Note / Memo

To: Suffolk County Council
From: Royal HaskoningDHV
Date: Friday, 20 March 2020
Copy:
Our reference: PB8301-RHD-ZZ-XX-NT-Z-0001
Classification: Project related

Subject: Pedestrian Crossing Assessment Associated with the Proposed Residential Led Mixed-Use Development at Land near Haverhill, Wilsey Road, Little Wratting, Suffolk (Planning Application Reference DC/19/0834/RM)

Insert 1.1: Proposed Pedestrian Crossing Locations

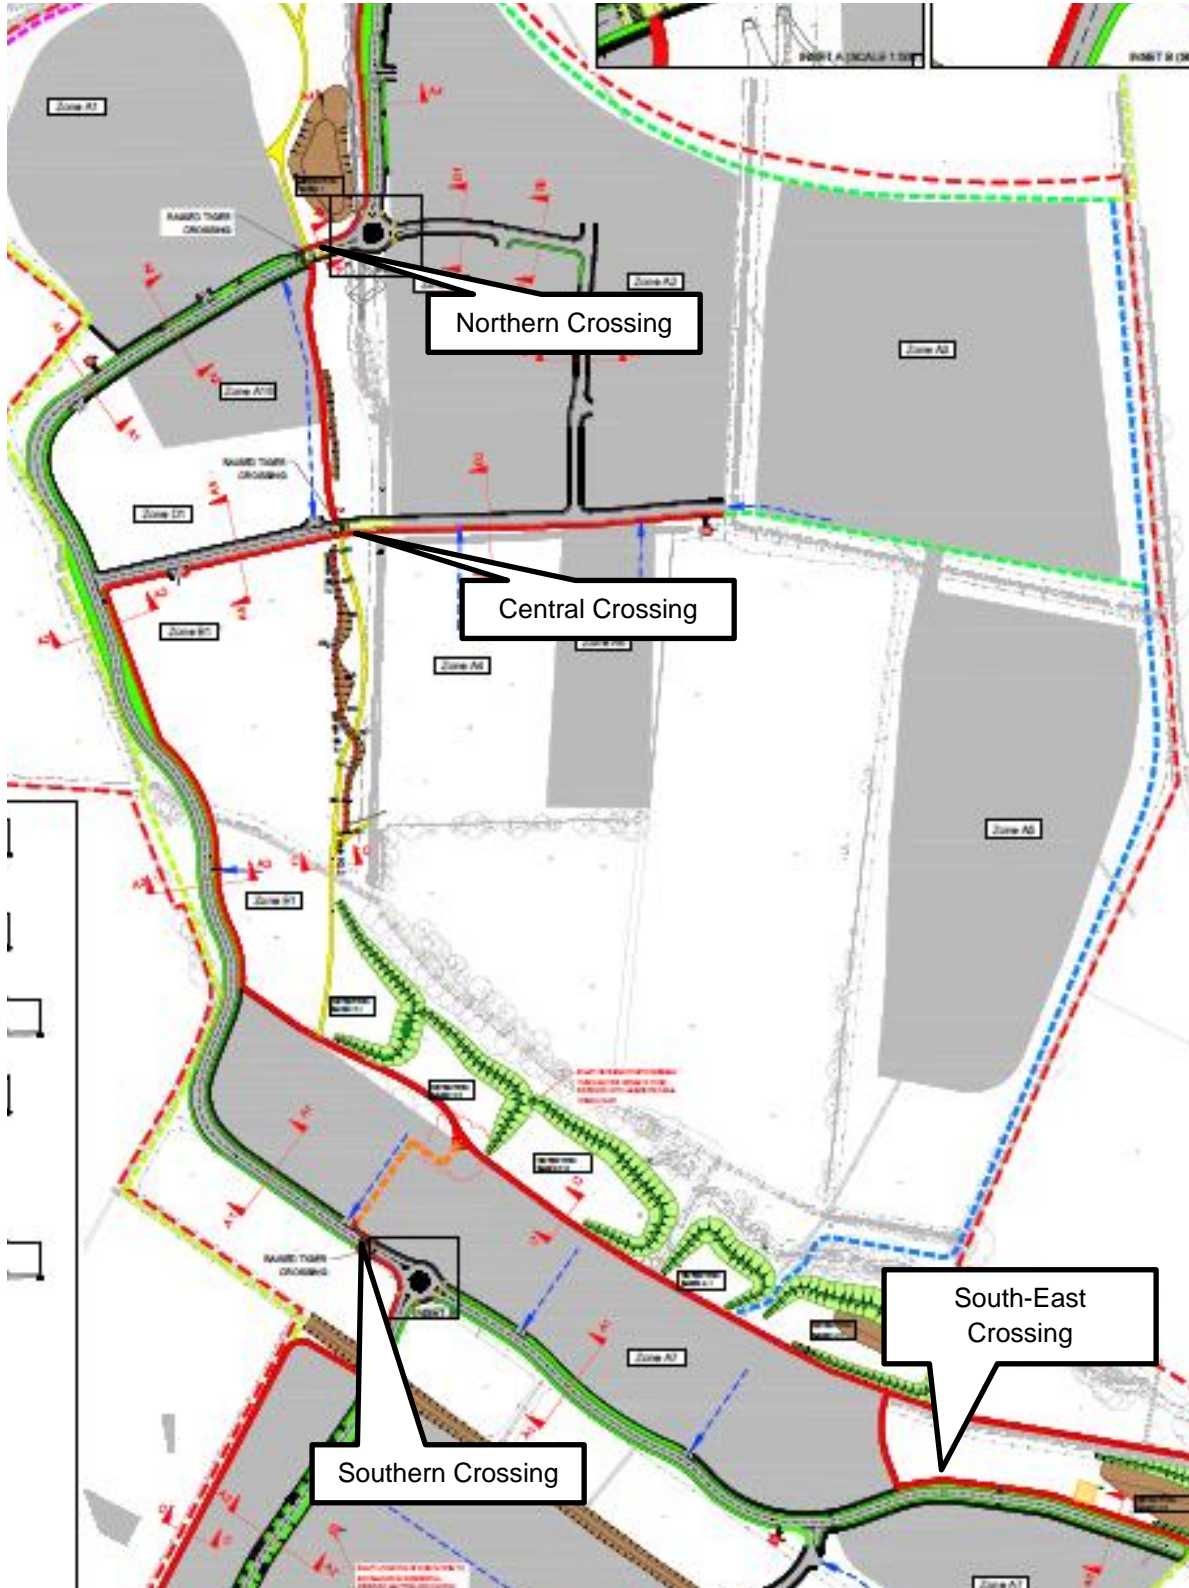
- “The spine road design indicates several Zebra or Tiger (cycle Zebra) or uncontrolled crossing points. The proposed traffic flows and potential for higher speeds will not enable this type of crossing to operate safely. Given the traffic flows expected through the site formal push button Puffin or Toucan crossings will be required on key pedestrian and cycle desire lines.”*

- 1.1.3 Three pedestrian crossing points are proposed on the proposed internal highway network. The proposed crossings would facilitate north-south pedestrian and cycle movements and would be provided in the form of Tiger (cycle Zebra) crossings. The locations of the proposed crossings are indicated in **Insert 1.1**.

- 7.2.1 The assessments have considered various crossing types, including informal, Zebra and signal controlled crossing. The appraisals have demonstrated that informal crossings would provide an appropriate level of provision given the existing and future traffic and pedestrian demand, however, given the high proportion of school children using the crossings in the AM peak, Zebra crossings are proposed at all three crossing locations.
- 7.2.2 In all three locations, the forecast PV² did not exceed the recognised thresholds for requiring a controlled pedestrian crossing. Furthermore, it is considered that there is no overriding need for signal controlled provision in any of the four locations.
